FED. ROAD DIST. NO.	STATE	FED. AID PROJ. NO.	FISCAL YEAR	SHEET NO.	TOTAL SHEETS
HAWAII	HAW.	BR-STP-056-1(35)	2000	C.O. 17	70

WAIKAEA BRIDGE WIDENING

KUHIO HIGHWAY-WAIKAEA BRIDGE WIDENING
Fed. Aid Proj. No. BR-STP-056-1(35)

SECTION B
Scale: 3/8"=1'-0"

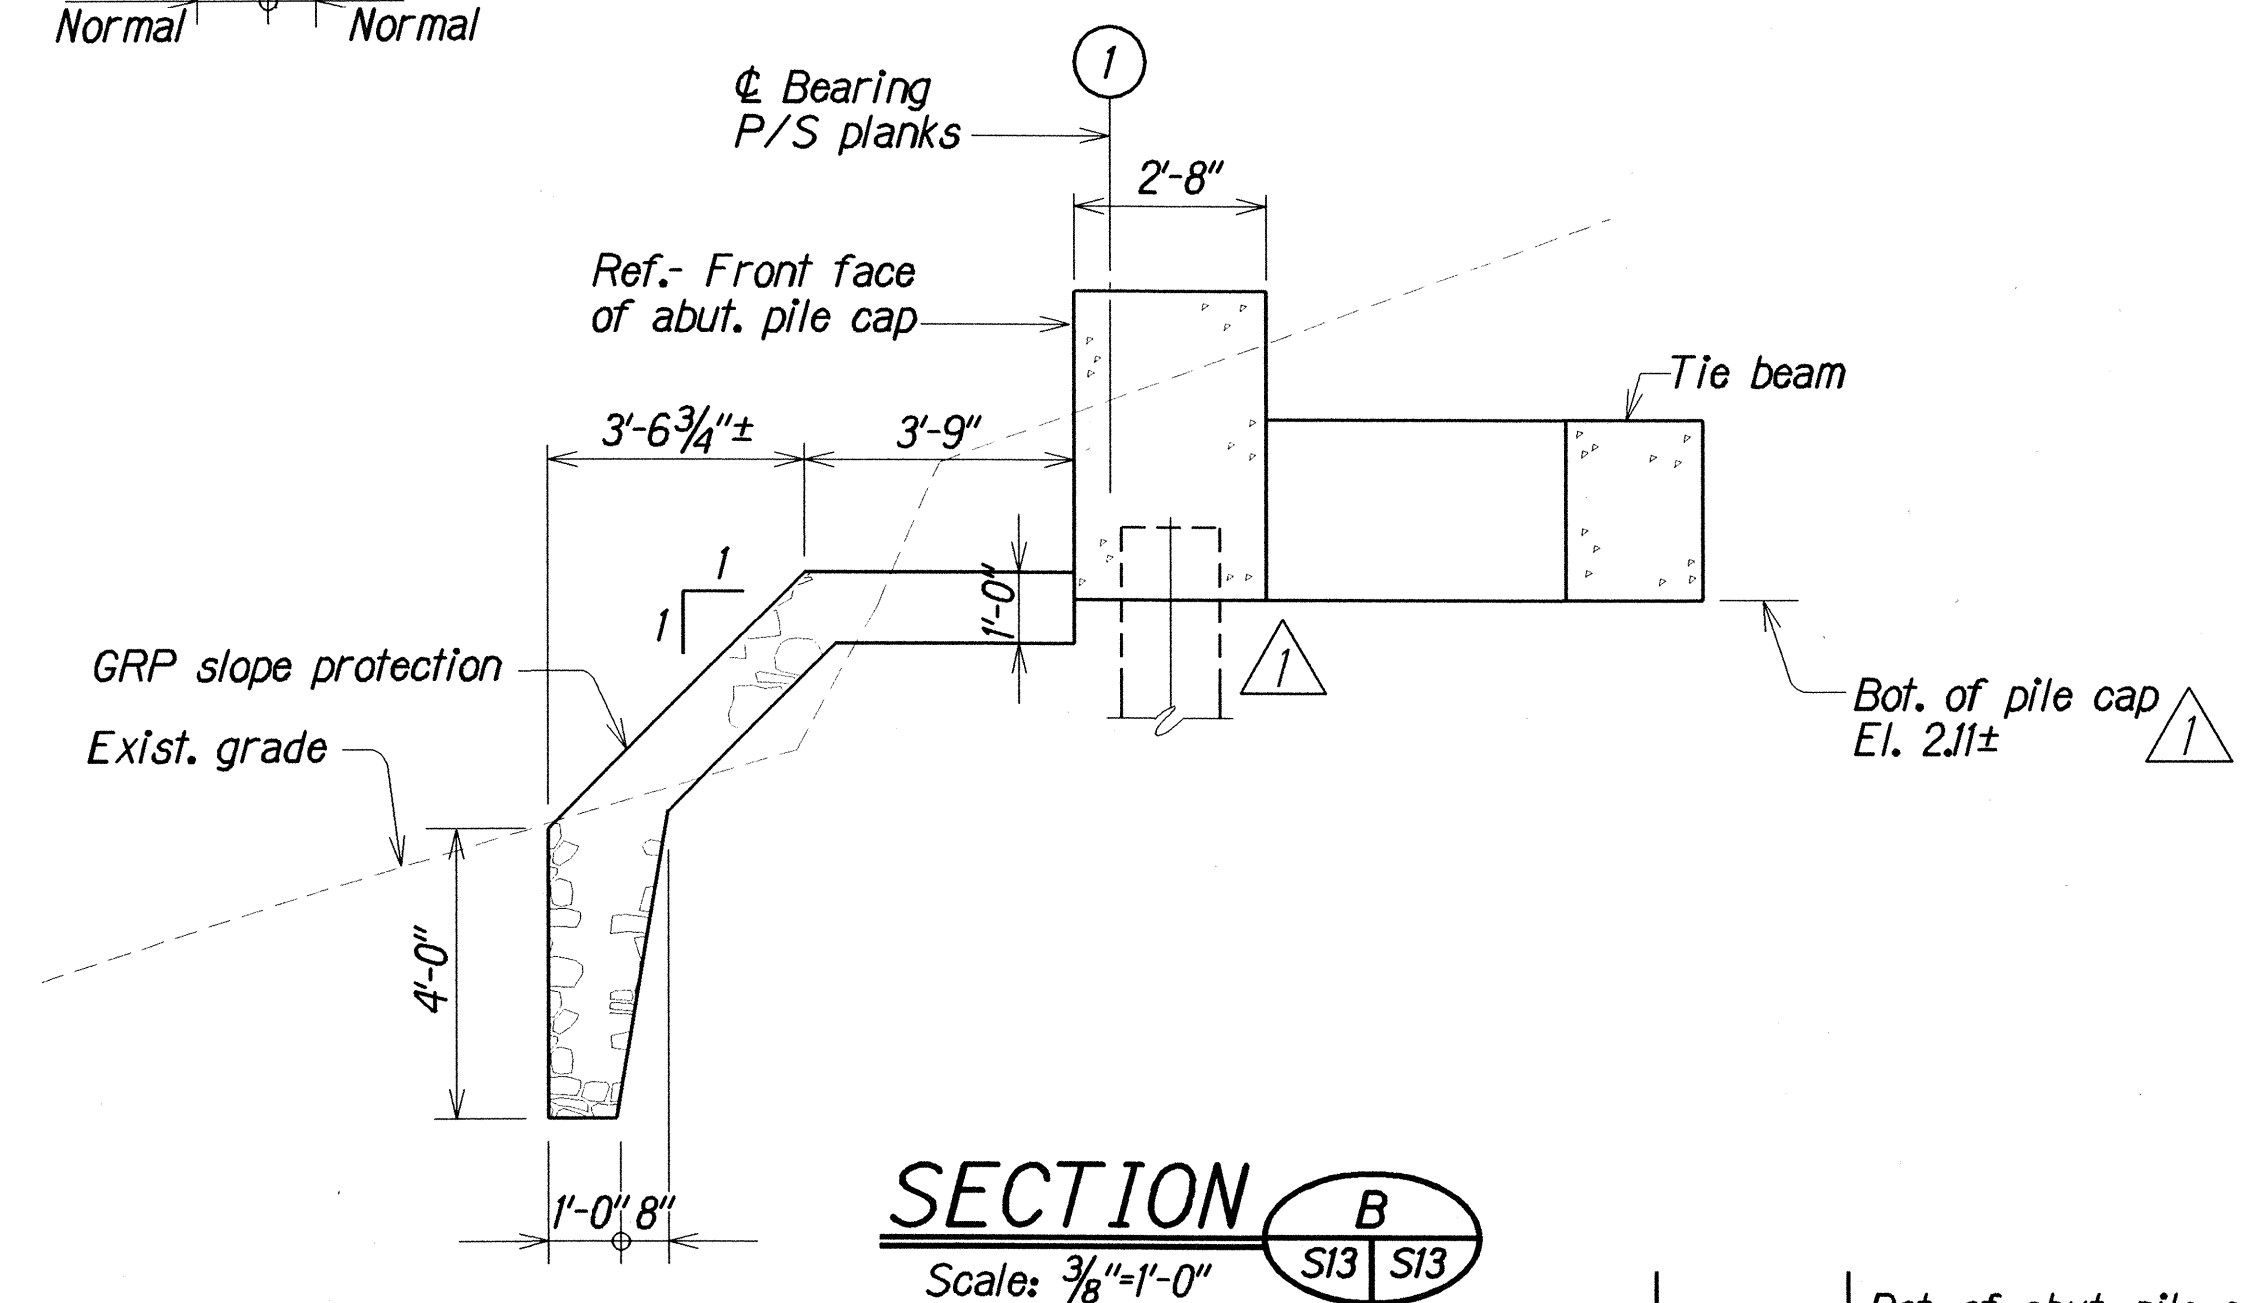
1
6/6/01
Bot. of abut. pile cap elevation changed. Piles, bridge, wingwall & abut. pile cap, lowered to accomodate changes. GRP removed behind front face of abut. pile cap. Labels moved and changed for clarity. Note #1 added.

PARTIAL PLAN
(SHOWING LIMITS OF GRP AT END POST NO. 4)
Scale: 3/8"=1'-0"

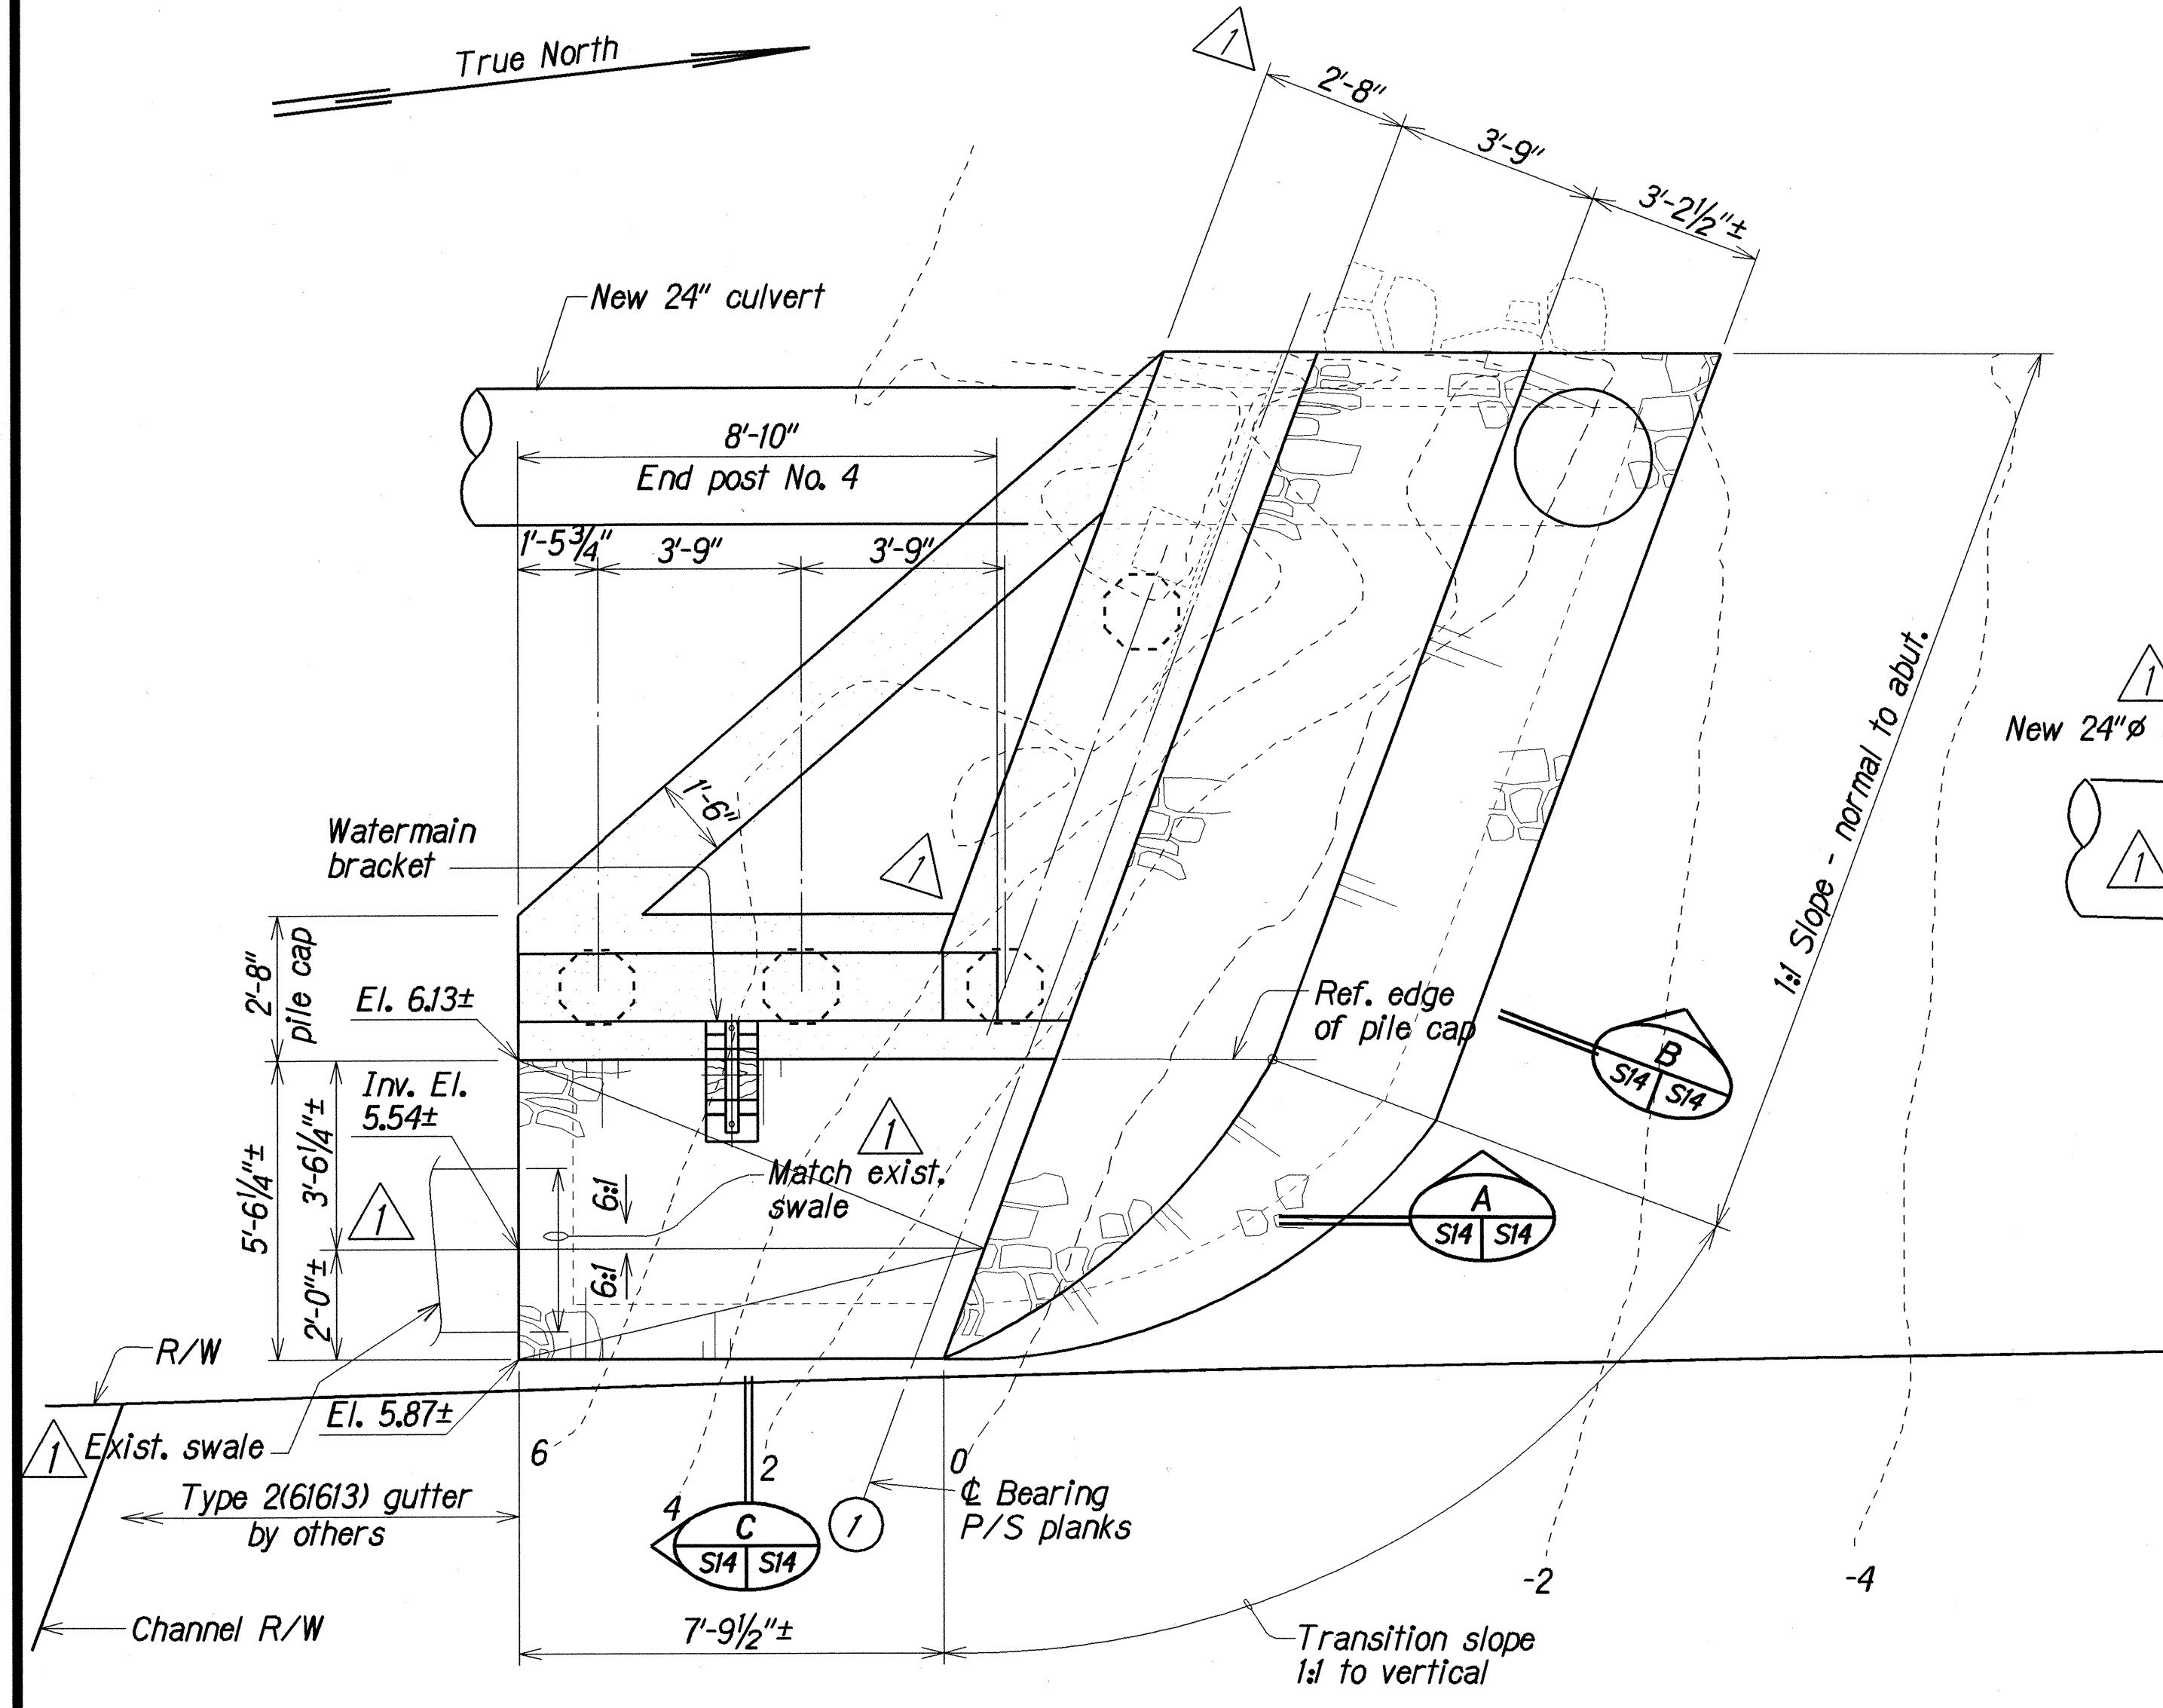
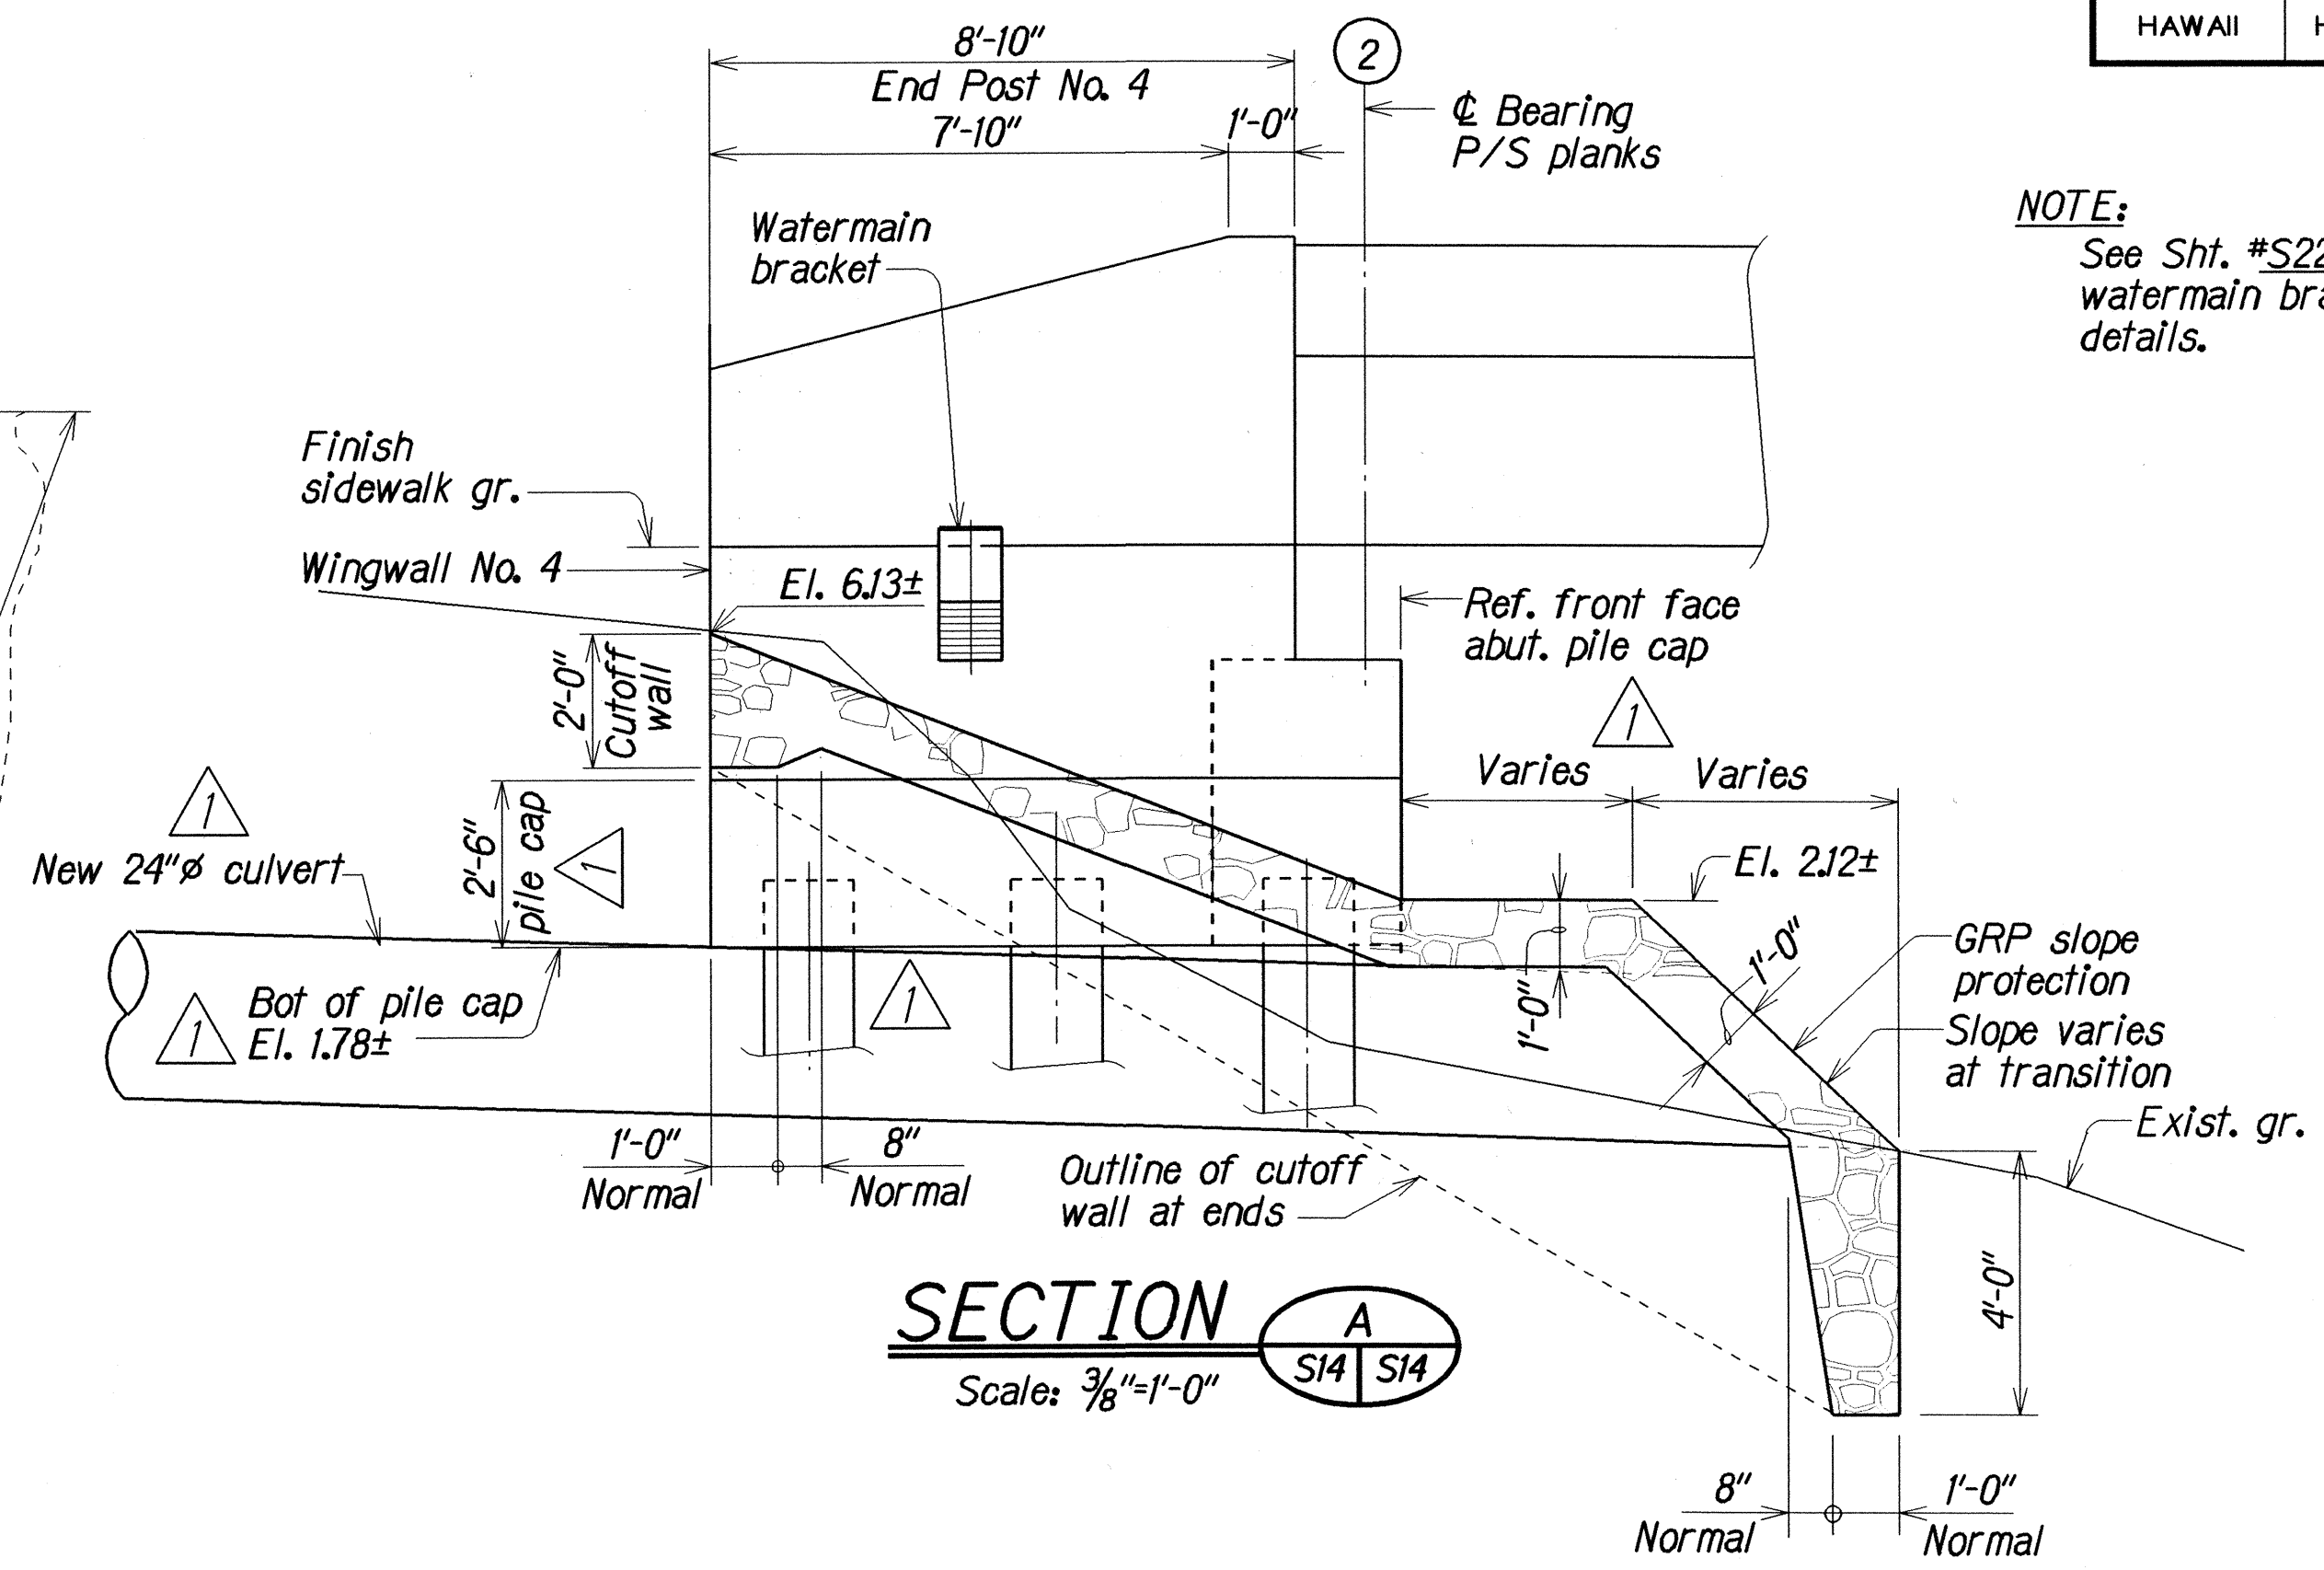
1
6/6/01
Bot. of abut. pile cap elevation changed. Piles, bridge, wingwall, abut. pile cap & 24"Ø culvert lowered to accommodate changes. GRP removed behind front face of abut. pile cap. Labels moved and changed for clarity. Note #1 and dimension added. Slope matched with exist. swale.
